FORT CALHOUN UNIT 1
TECHNICAL EVALUATION REPORT
ON THE INDIVIDUAL PLANT EXAMINATION
BACK-END ANALYSIS

Prepared for the U.S. Nuclear Regulatory Commission
Under Contract NRC-04-91-068-40
May 1996

SCIENTECH, Inc.
11140 Rockville Pike, Suite 500
Rockville, Maryland 20852

Figure 1. Fort Calhoun Station Unit 1 reactor cavity (reproduced from figure 4.2.1.1, page 4.2-10 of the submittal).

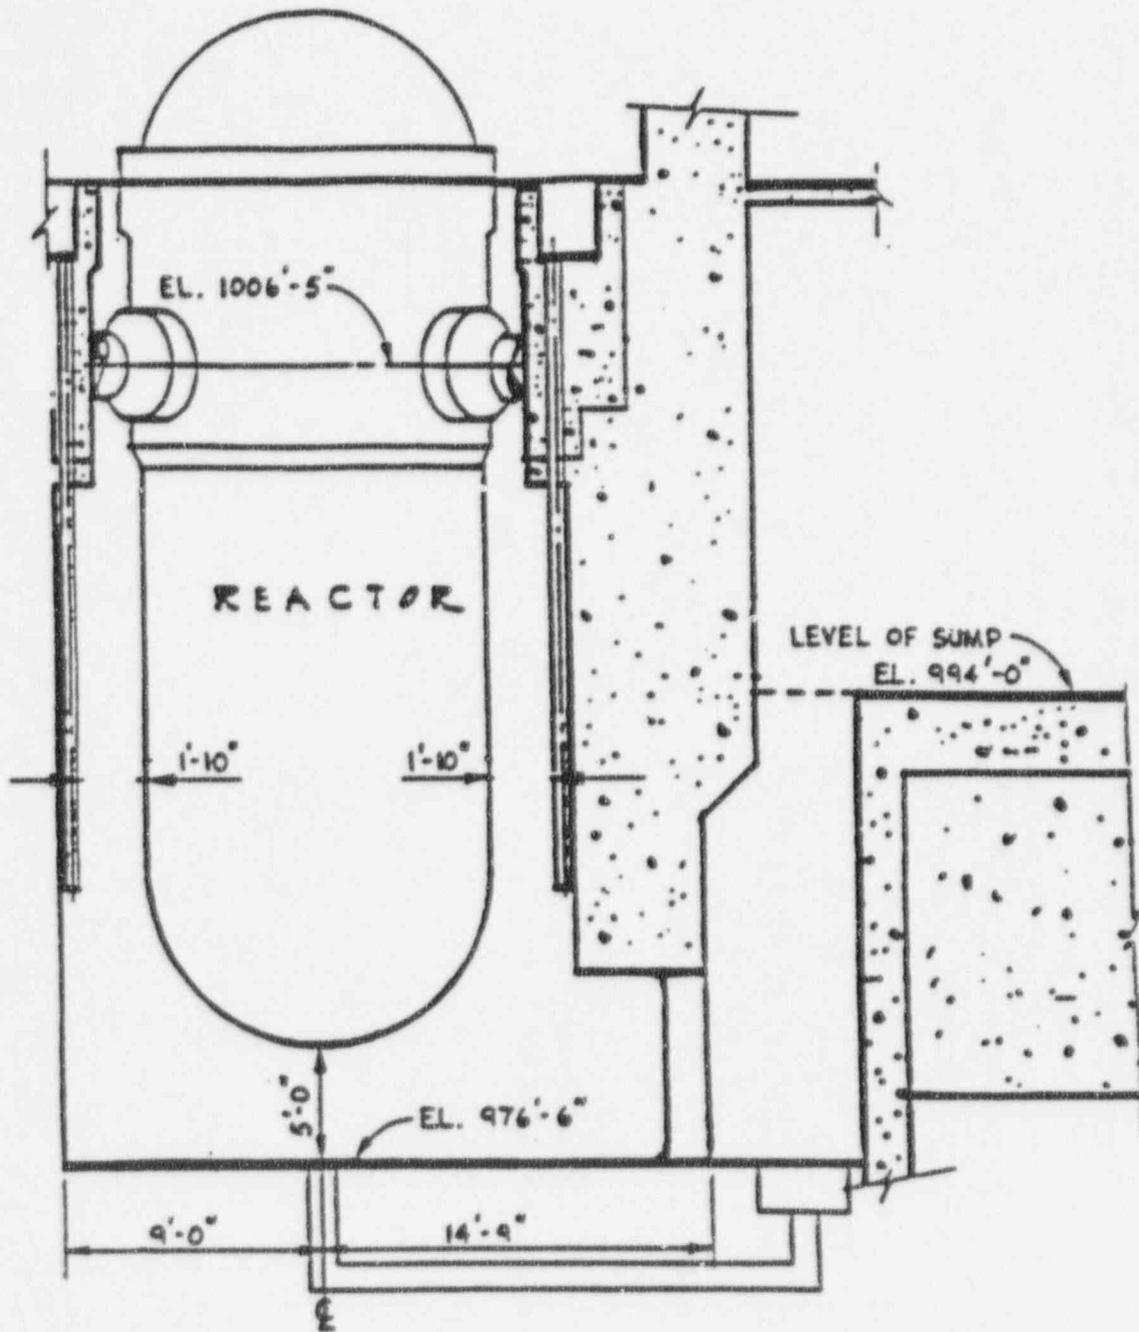
External Vessel Cooling. As shown in figure 1 of this report (reproduced from figure 4.2.1.1, page 4.2-10 of the submittal), the FCS reactor vessel sits partially below the bottom floor of the containment with about 12.5 feet of the reactor vessel residing below the emergency safeguards recirculation pump. Therefore, the vessel is expected to be submerged significantly for all reactor transients that either use containment recirculation (e.g., LOCAs) or provide sufficient containment spray flow to fill the emergency sump. After reviewing the cavity geometry, available water sources, and the results of the plant accident simulations performed with MAAP computer code, the IPE team found that the loss of sufficient inventory to cover the core would result in submergence of the reactor vessel lower head if containment heat removal is maintained.

Note that although the cavity flooding would enable external vessel cooling, it increases the likelihood of occurring ex-vessel steam explosions in the event of vessel failure.
